NOPOWER, V_{On_PD} , and V_{Off_PD} v122

This comment addresses r01-450, 449, 347, 451, 348, 349, 452, 227, 314, 353, and 238.

Figure 145–26—Single-signature PD state diagram (continued)

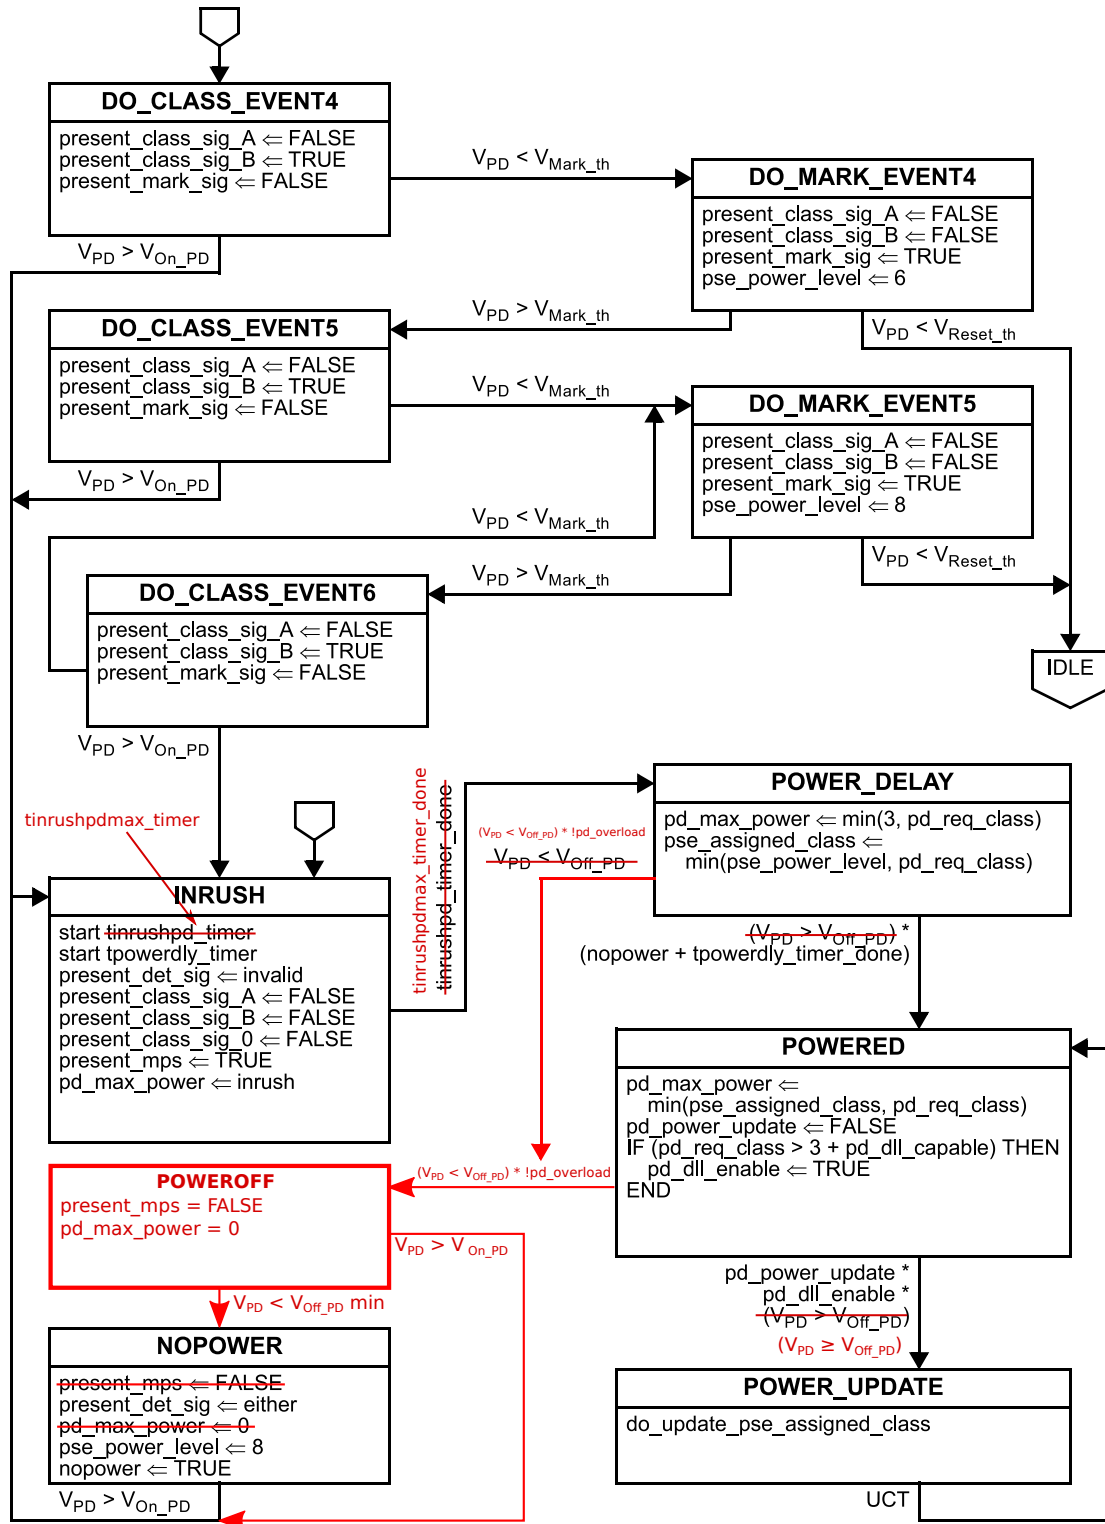
There is a discrepancy between the text in 145.3.8.1, dealing with PD turn-on and turn-off behavior and the behavior of the state diagram. The specification V_{Off_PD} and V_{On_PD} is intended for steady state condition, excluding peak power draw and transient events. After all, a PD that is drawing peak power may have a V_{PD} that is outside of the V_{Port_PD-2P} range, and as such the PD would be permitted to turn off.

The state diagram implements this turning off of the PD with the NOPOWER state. Because the state diagram reacts instantaneously, depending on the value of V_{Off_PD} , it can happen that peak power draw, or a transient event causes the PD to transition to NOPOWER. Because NOPOWER is also used to specify behavior for PDs that are intentionally drawn back into mark/class/ V_{Off_PD} range, a conflict arises, because a pass through the NOPOWER state allows the PD to change its class event counter.

Another way to make an unwarranted pass through NOPOWER is for the PD to intentionally transition from INRUSH to POWER_DELAY before V_{PD} is in the V_{Port_PD-2P} range. This must also be prevented.

- the PD state diagram is forced to spend precisely 50 ms in INRUSH (the state, not the condition).
- the entry logic into NOPOWER is changed to be $V_{PD} < V_{Off_PD}$ min.
- Add requirement that states a PD can't turn off due to compliant peak power draw or transients.

Change Figure 145–26 as follows:

Update Figure 145–24 in the same manner as Figure 145–26.
